MONTGOMERY COUNTY PLANNING DEPARTMENT
 THE MARYLAND-NATIONAL CAPITAL PARK AND PLANNING COMMISSION

MCPB
 Item #
 7/14/11

MEMORANDUM

SUBJECT: Local Map Amendment G-907

Illustrative Portion of Schematic Development Plan

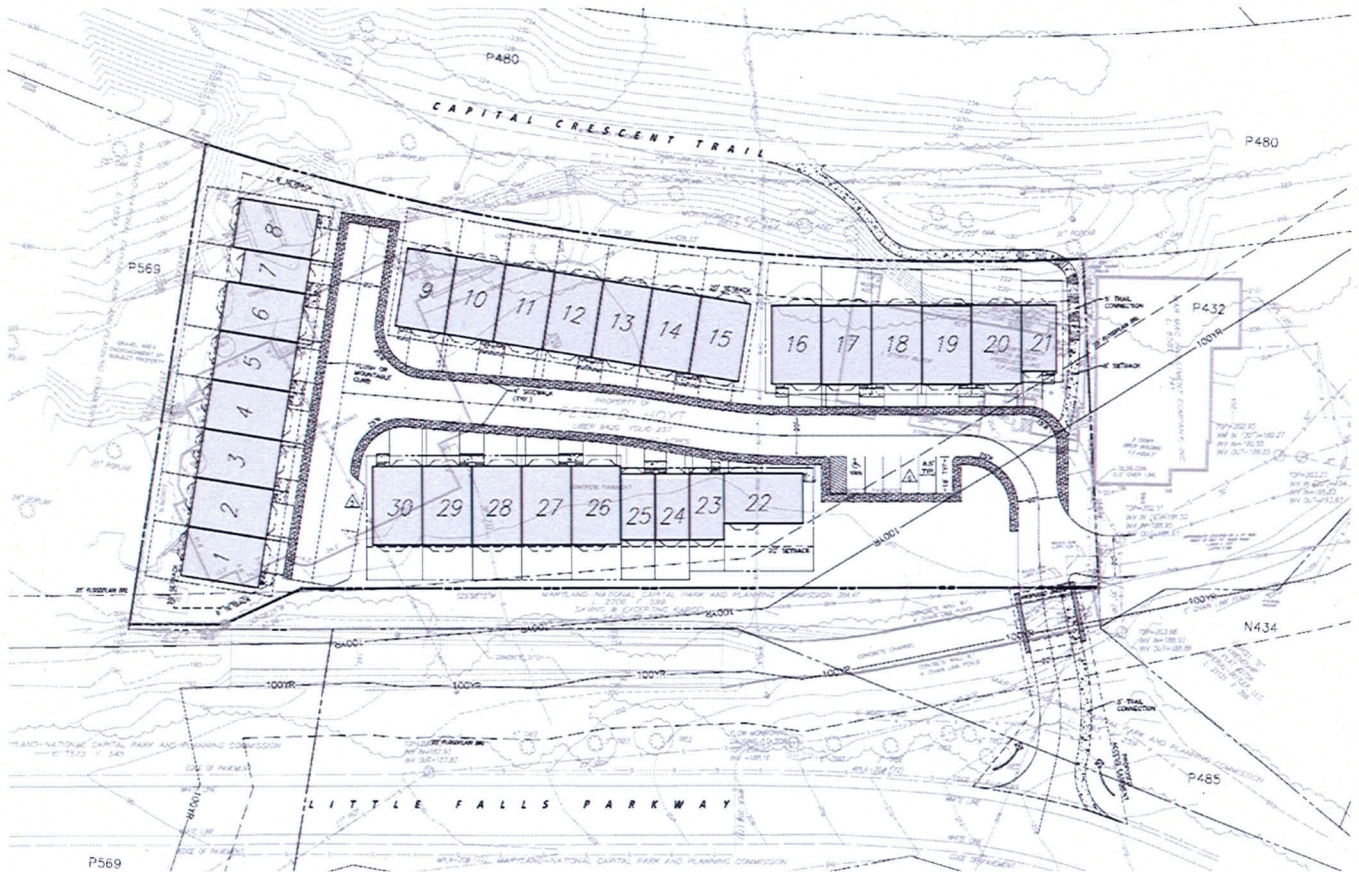
shown above. Staff recommends the Board encourage the applicant to proffer additional binding elements during the public hearing that go to the heart of compatibility, such as binding elements relating to the proposed open space, setbacks, proposed building heights, and percentage of MPDUs.
